Case No.: DCI 2003-00058

Project Name: WALMART #5347-00 (ESTERO GOLF RESORT MPD)

Zoning Notes: Z-04-048, DCI 2003-00058, REVISE MASTER CONCEPT PLAN TO ACCOMODATE DEVELOPMENT OF A WALMART SUPERCENTER, ADJUST THE LOCATION OF THE ACCESS TO US 41, ADD TO LIST OF PERMITTED USES, AND ELIMINATE CERTAIN CONDITIONS OF THE PREVIOUS APPROVAL; CONDS. 18 OCT 04

Figure 4

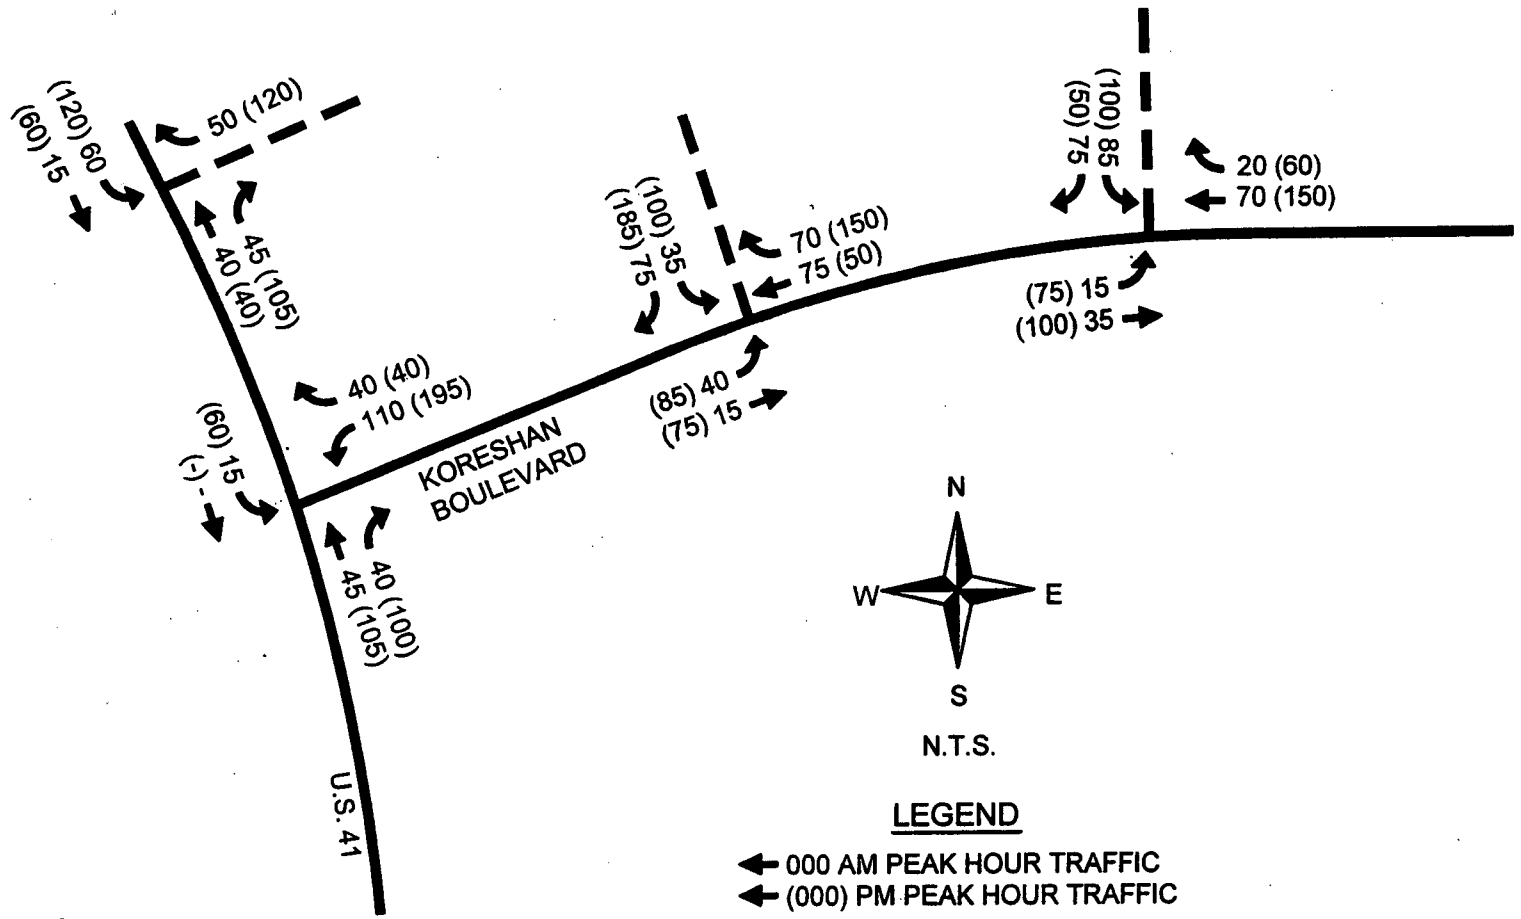
1) The site traffic assignment numbers in Figure 4 do not add up in some instances. The number of vehicles departing the eastern driveway on Koreshan Boulevard proceeding westbound do not match the number approaching the western driveway in the PM peak hour. Similarly, the vehicles departing the western driveway do not equal the number approaching the U.S 41 intersection. This inconsistency occurs in both the AM and PM traffic distribution. Figure 4 and any dependent intersection analyses should be revised.

Figure 4 has been revised as a part of this response. See the revised TIS.

Sheet No. L-1

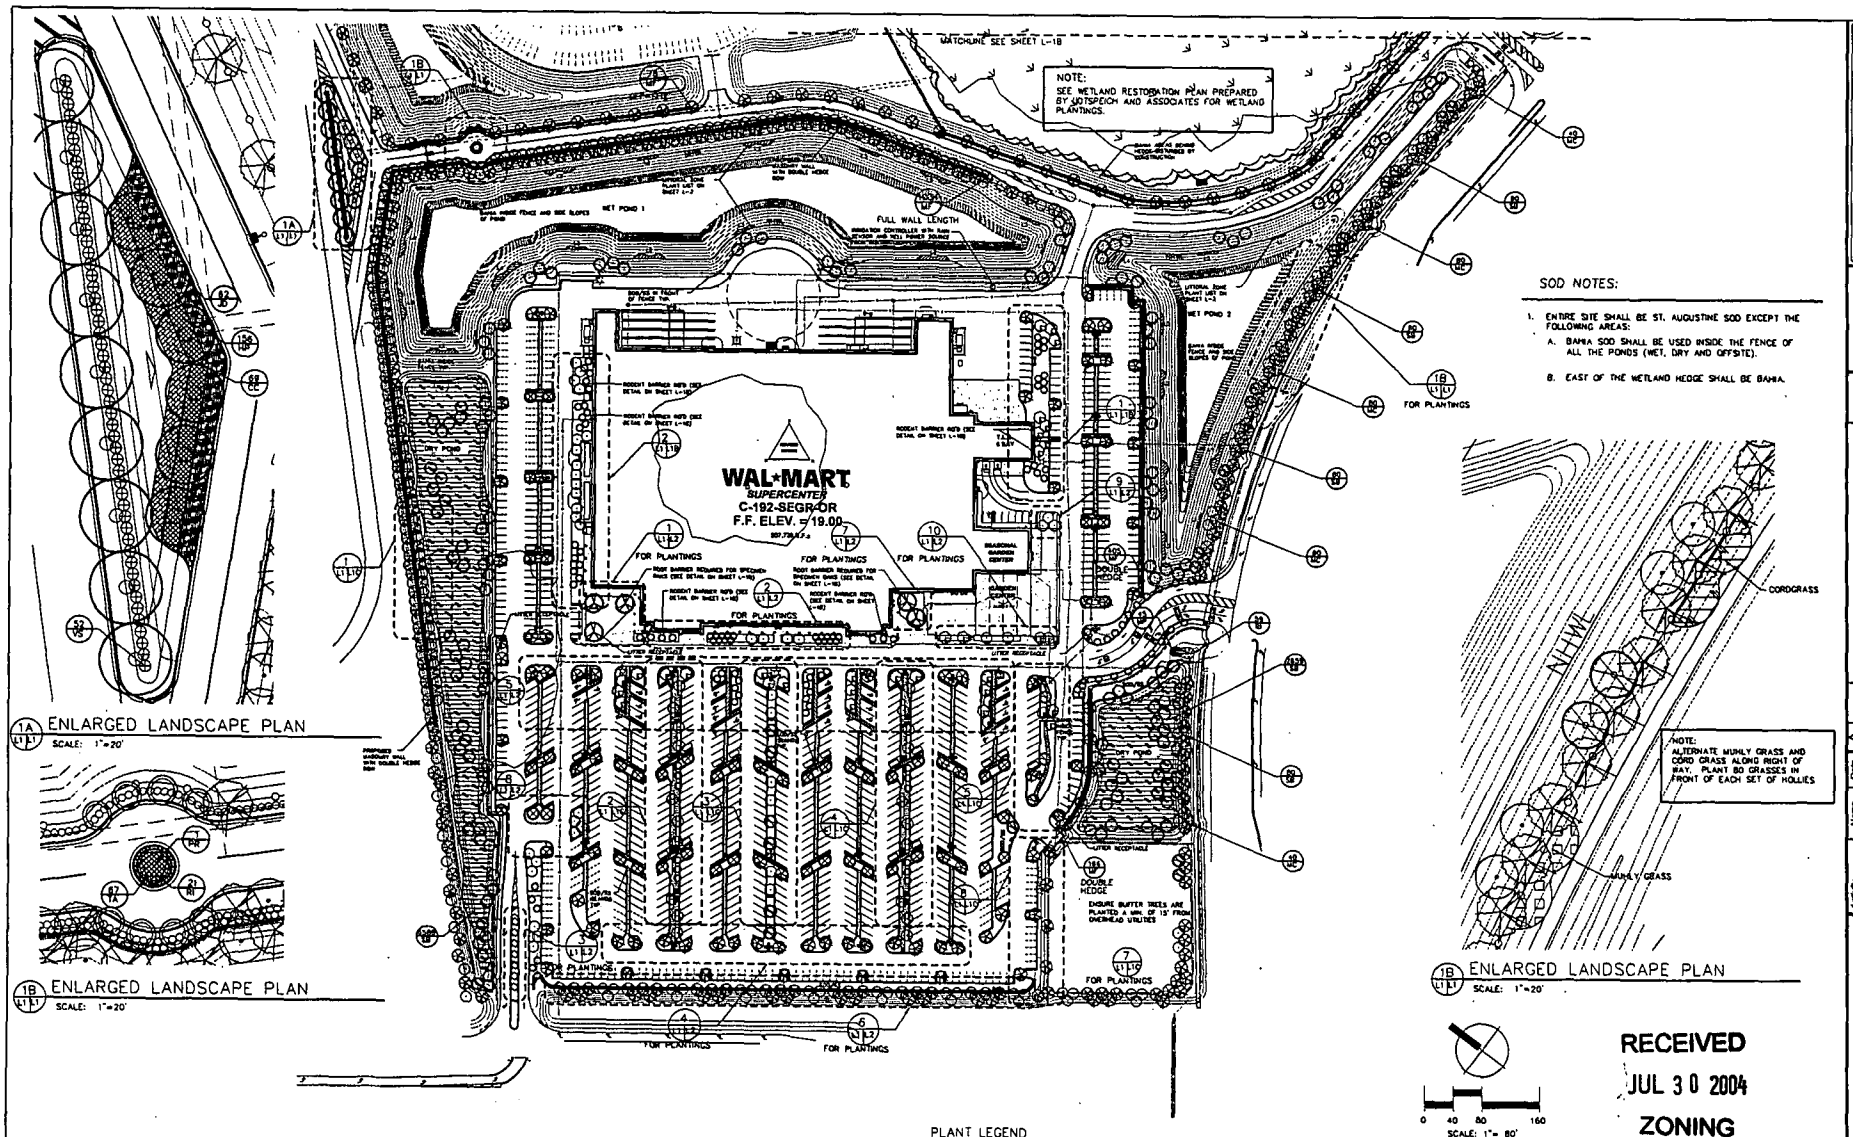
- Correct the notations on Sheet L-1 that incorrectly labels Enlarged Landscape Plan areas 1A and 1B.

Sheet L-1 has been revised.

Sheet No. C-2

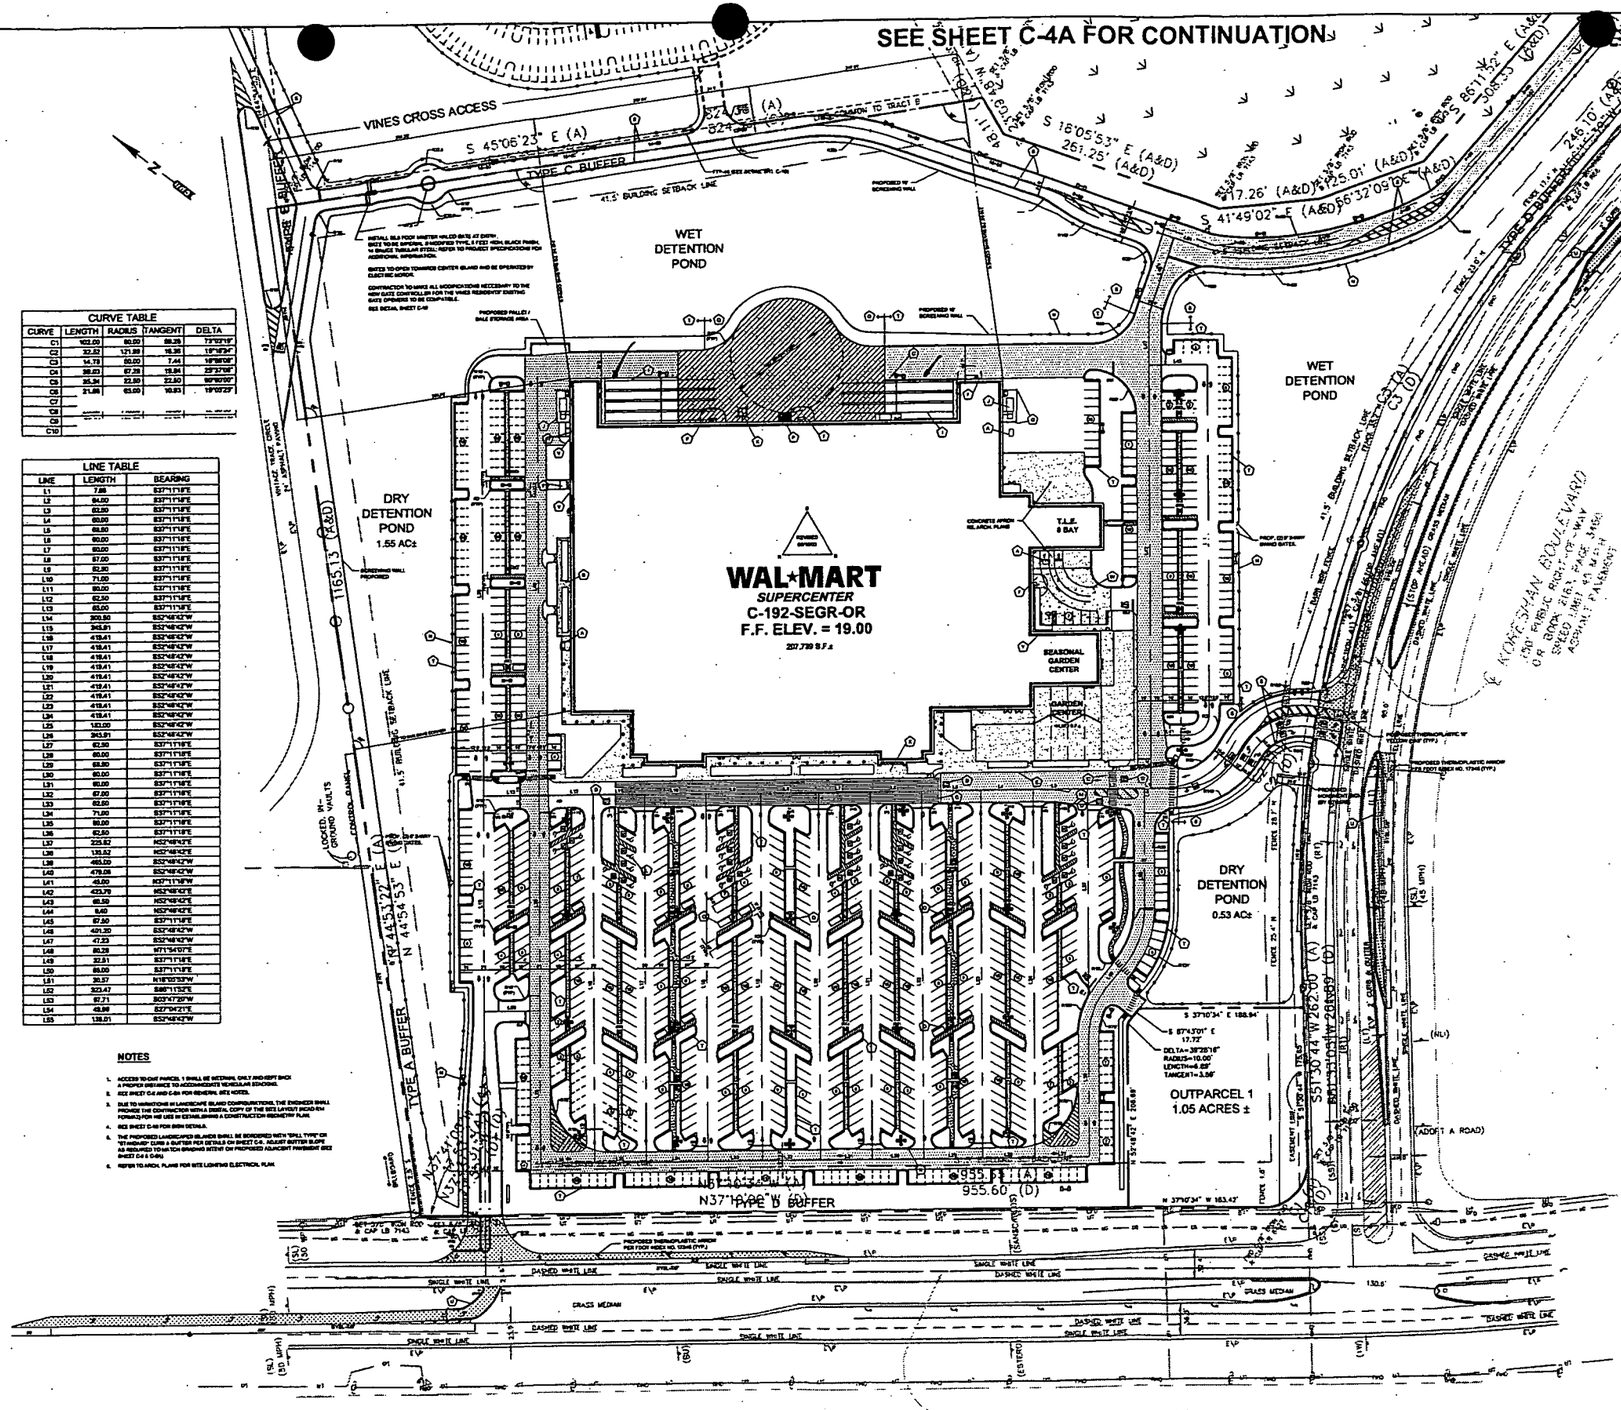
Please submit a FLUCCS and soils map at the same scale as the MCP.
Please refer to the new Sheet C-2 of the Amendments to the Master Concept Plan.

Per our meeting on January 22, 2004, we have revised Sheet C-2 to show an arrow towards the multi-family tract.
